Planning Commission Work Session Discussion Points

September 8, 2015

Re: PUD-113

Applications for: 1) rezoning of an approximately 9-acre site at 6900 Valley Trails Drive from R-1-6,500 (One-Family Residential) District to PUD-MDR (Planned Unit Development – Medium Density Residential) District and for PUD Development Plan approval to demolish the existing religious building and construct 43 detached single-family age-restricted homes with related site improvements; and 2) Vesting Tentative Map Approval to subdivide the approximately 9-acre parcel into 43 single-family residential parcels and 6 common lot parcels.

SITE DEVELOPMENT PLAN
THE VILLAGE AT VALLEY TRAILS
 CITY OF PLEASANTON, ALAMEDA COUNTY, CALIFORNIA
 FOR: PONDUGIA HOUSE

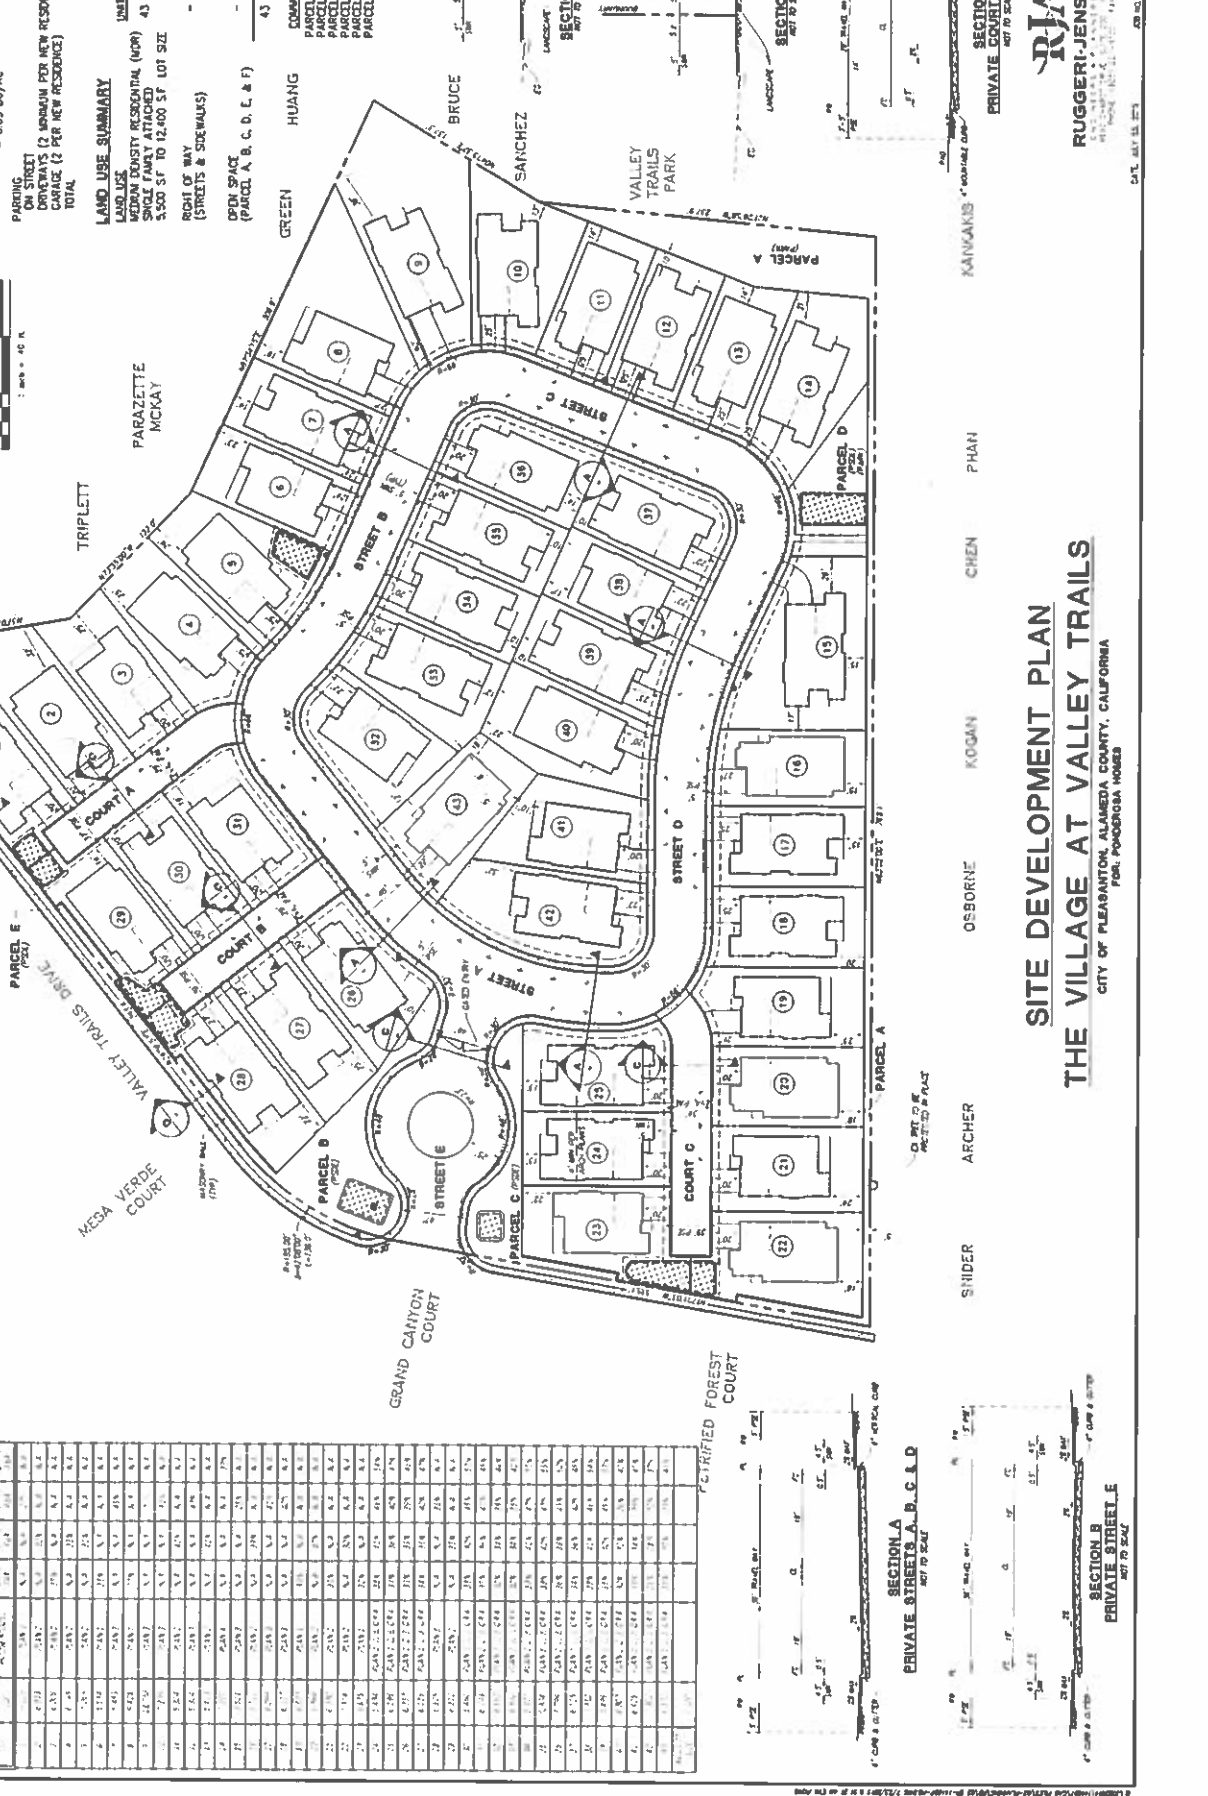
As proposed, the layout of the development does not meet the policy and programs outlined above. Staff does not support gating the community and the development will need to be redesigned such that it meets the City's Complete Streets Policy and City standards. Please be aware that this may require the development to have public streets and courts. Staff strongly encourages the

- a. The proposed layout of lots does not integrate with the surrounding neighborhood as the layout/configuration of the development plan is not consistent with the surrounding development pattern. In particular, the development is walled-off from the surrounding neighborhood and park. Lots adjacent to Valley Trails Drive should be orientated such that they front Valley Trails Drive. While the project is within the allowed density, smaller building footprints are encouraged to allow for more open space between properties (existing and new) and a better transition with Valley Trails Park. Staff strongly encourages you to explore design/layout solutions that better transition with the park/green space and existing development such that the proposed development functions as a unified neighborhood. Proposed residential units should either front portions of Valley Trails Park, or include park-facing backyards with low walls. The project as currently proposed would establish a masonry (or stucco) wall at the terminus of the park, obstructing views of the Pleasanton Ridge and creating "dead space" in the western portion of the park.

- b. The proposed perimeter wall does not integrate with the surrounding neighborhood and would result in visual impacts that can be addressed by substituting traditional good neighbor wood fencing. The development gate is not supported and staff urges you to remove it from the proposal. A gated community is not appropriate in Valley Trails and is inconsistent with the City's General Plan (see General Plan Circulation Program 7.4 on page 3 of this correspondence). An 8-foot tall masonry wall is too massive and should be replaced, particularly along the Valley Trails Drive and park frontages of the site.

- e. The proposed location of the mailbox kiosks will need to be shown on the plans.
- f. A separated sidewalk parallel to the street curb, consisting of a five-foot wide sidewalk and a five-foot wide landscape area between the sidewalk and back of curb for shade trees should be provided along all new streets. The separated sidewalk along Valley Trails Drive should be preserved and enhanced.
- g. Staff strongly encourages you to locate the bioswales on community parcels/lots, similar to parcels B, C and D, and not on private parcels/lots (please refer to lots 1, 5, 22, 23, 28, and 29).

- a. The site plan shows front yard setbacks ranging from 20 feet (lot 1) to 40 feet (lot 9). The setbacks shown on the plans are taken from the curb to the garage. The depth of the driveways will need to be a minimum of 22 feet, measured from the interior side of the sidewalk to the garage. House setbacks will need to be measured from building wall to the property line. Staff may support reduced front yard setbacks, excluding the driveway depth, where usable porches are provided. Spacious porches facing the street should be provided at least on Valley Trails Drive.

- b. The rear yard setback shown on the plans ranges from 10 feet (lot 34) to 56 feet (lot 1). The rear yard setback should be a minimum of 20 feet for all lots in order to provide a usable and functional outdoor area that provides for light and open space access for the residents.

- c. One side yard setback was noted on the plans (lot 15). Overall, the site plan layout does not offer a great deal of separation between buildings (i.e., lots 41 and 42). The homes should be reduced to a square-footage size that would provide more separation between the buildings or the lot sizes should be increased to allow for more separation between structures.

29. Should you decide to pursue the perimeter wall, details of the height of the wall (fished grade to the top of the wall) on Valley Trails Drive (please refer to Section D and E) are required with future plan submittals.

36. The radii in the roundabout are smaller than the inside turn and outside sweep of a LPFD truck. Please revise the plans to accommodate LPFD truck inside turn and outside sweep.
